NUMBER: SB 500-32-014, Rev D  
MODEL: ECLIPSE EA500  
SUBJECT: Left Hand MLG Trunnion Repair/Replacement

This bulletin repairs or replaces the main landing gear trunnion.

This Service Bulletin provides procedures to repair or replace the Main Landing Gear Trunnion on an Eclipse aircraft.

**Figure 1. MLG Main Fitting Nameplate Location**

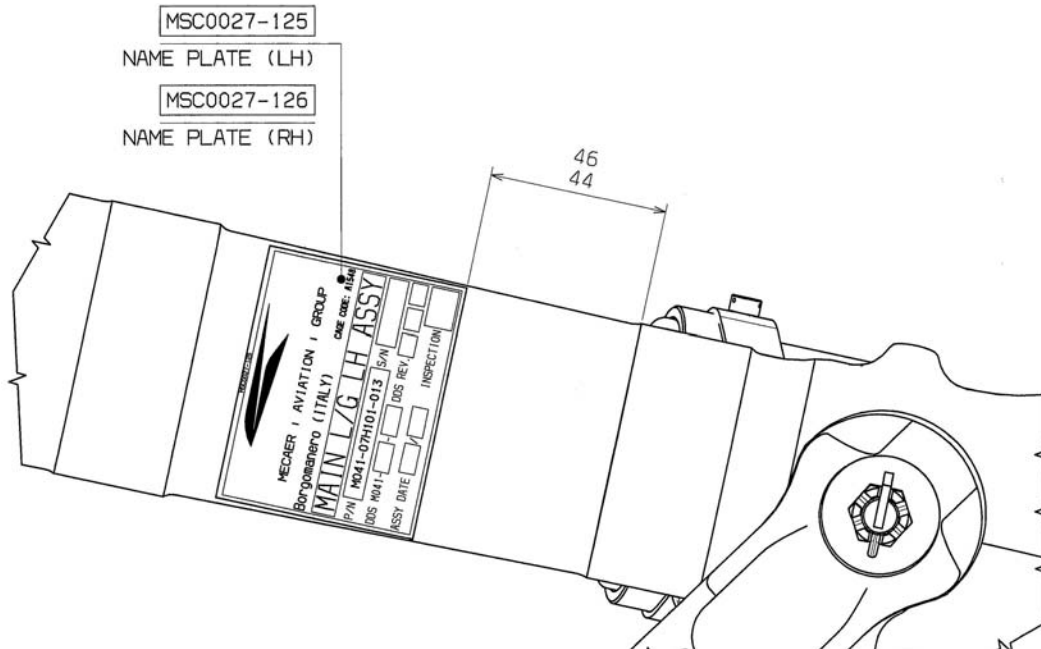
- (3) MFG DATE/ASSY DATE to remain as is on the original nameplate (do not change the date to the current date).
- (4) Original nameplate shall have a large black “X” marked across the nameplate from corner to corner with permanent marker to void the nameplate. Original nameplate to remain attached to the old Main Fitting.
- (5) Locate position for new nameplate installation on the new MLG Main Fitting 44-46 mm (1.73-1.81 inch) up from the lower strengthening band in accordance with [Figure 1](#).
- (6) Pre-bend new Nameplate to conform to the contour of Main Fitting.

- (7) Prepare the Main Fitting surface in the location of the nameplate by thoroughly cleaning the surface with Aliphatic Naptha TT-N-95B Type II (or equivalent).
- (8) Ensure the Main Fitting surface is completely dry after cleaning by using a clean dry cloth.
- (9) Remove adhesive backing from the nameplate.
- (10) Apply Epoxy Adhesive MMM-A-132, Type 1, Class 3 (Metalset A4 or equivalent) under the entire surface of the nameplate.
- (11) Attach the nameplate to the MLG Main Fitting in the correct location.

- (12) Apply liberal bead of adhesive around all edges of nameplate.
- (13) Temporarily secure nameplate to Main Fitting using non-marking tape (Masking Tape or equivalent).
- (14) Allow adhesive to dry.
- (15) Remove temporary tape.
- (16) Install trunnion per Section F. — MLG Main Fitting Installation.

**Figure 2. Trunnion Identification Pad Area**

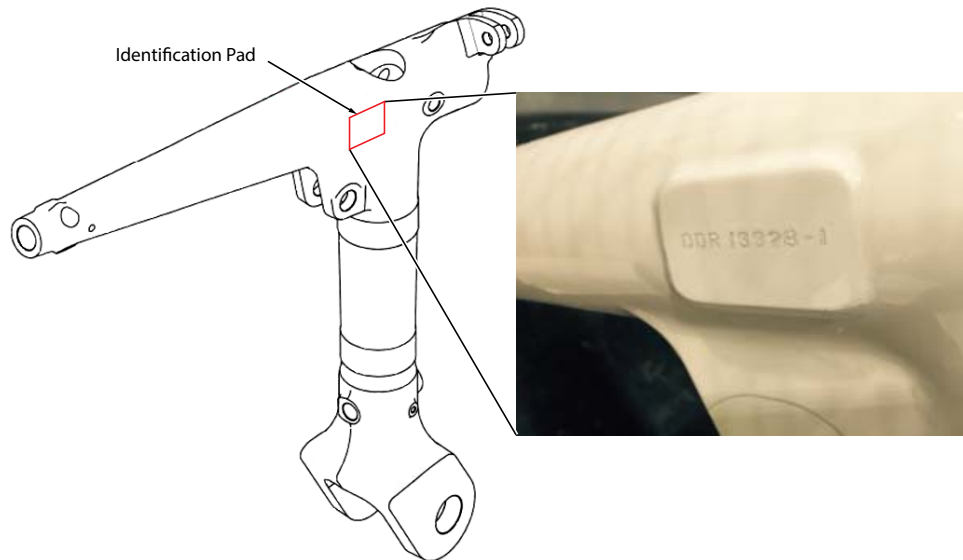
- (1) Review log book entries, proceed based upon the following:
  - (a) If trunnion was replaced per TSR from EAI, POST SB 500-32-012, and contains a Service Bulletin (SB) number and/or a DDR# as shown in [Figure 2](#), complete compliance record and return to EAI. No further work under this SB is required.
  - (b) If trunnion was not replaced, based on facility authorization, repair or replace trunnion per step 3.B. or 3.C. of this bulletin, as applicable. See “Facilities Authorized to perform Service Bulletin:” on [page 3](#).

- (1) Ensure the replacement trunnion contains at least one of the following (Refer to Figure 2):
  - Marked indication of SB completion on or near the identification pad area.  
(Accomplished after repair procedure.)
  - Engraved DDR# from Mecaer on the identification pad.
